City of Somerville

ZONING BOARD OF APPEALS

TO: Zoning Board of Appeals
FROM: Planning, Preservation & Zoning (PPZ) Staff
SUBJECT: 21 Eastman Rd., P&Z 2021-121
POSTED: January 28, 2022

RECOMMENDATION: Steep Slope Special Permit: Conditional Approval
Hardship Variances: Deny

Sheet Z-2 of the January 21, 2022 plan set, area in question outline in red:

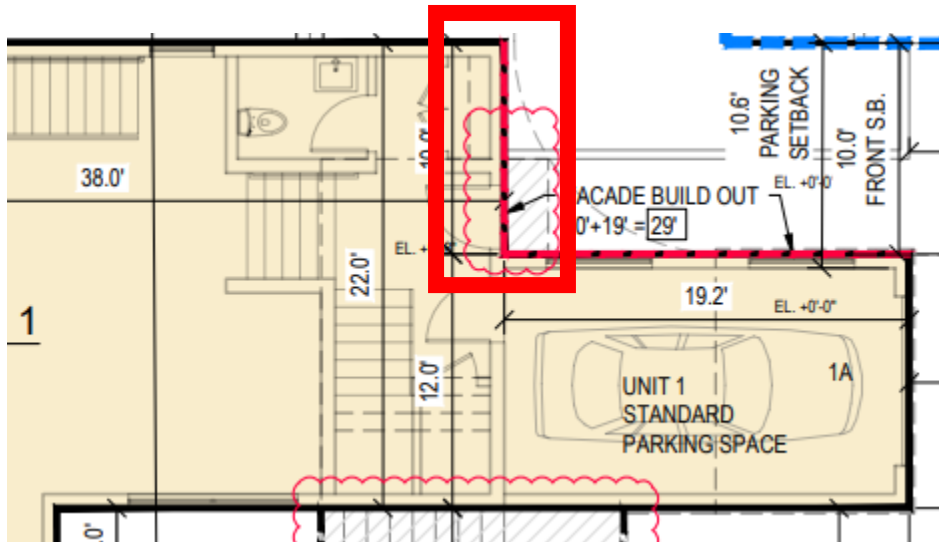
Upper Story Fenestration (1)

The upper story of the primary (east-facing) façade has no fenestration, but is required to have a minimum of 15% fenestration. Staff have annotated two images (in plan and in elevation) to indicate the area in question.

This could be easily remedied and the variance request nullified by providing fenestration in the area outline in red in the following images.
